## NOVI MEDICAL BUILDING (AKA MAPLES OF NOVI TENNIS COURTS) JSP21-33

Public Hearing at the request of AJSS Property, LLC for a request to amend the Planned Unit Development (PUD) Agreement & Area Plan for the Maples of Novi. The subject property contains 0.42 acres and is located in Section 2, east of Novi Road and south of Fourteen Mile Road. The applicant is proposing to remove the existing tennis courts on the site and construct a 2,558 square foot medical office.

**PLAN REVIEW CENTER REPORT**  
**Planning Review**  
**NOVI MEDICAL BUILDING (AKA MAPLES OF NOVI TENNIS COURTS)**  
 JSP 21-33  
 October 14, 2021

SHEET TITLE  
PHOTOMETRIC PLAN

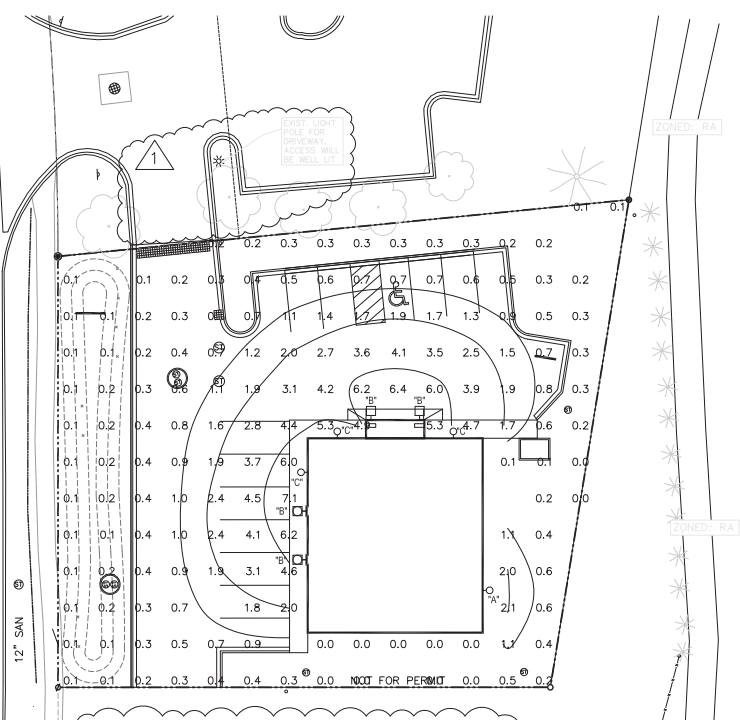
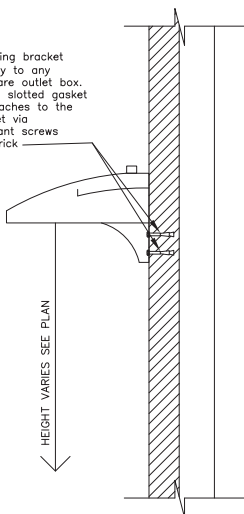
11. Lighting Plan (Sec. 5.7.A.ii): Please update the photometric plan to match the site plan in the next submittal.
12. Shared Access Easement: A shared access easement has not been indicated on the site plan. Please indicate if there is a shared access easement. If there is a shared access easement, please indicate the easement on the site plan and provide the Liber and Page Number.

**Response: Hours of operation have been provided on Sheet CS-01. Spillover information of light pole will be provided and shown on Sheet PH-1**

**Response: Standard notes are provided on Sheet PH-1**

**Response: A mounting detail for lighting fixture is shown on Sheet PH-1**

**Response: The average light level is shown on Sheet PH-1**
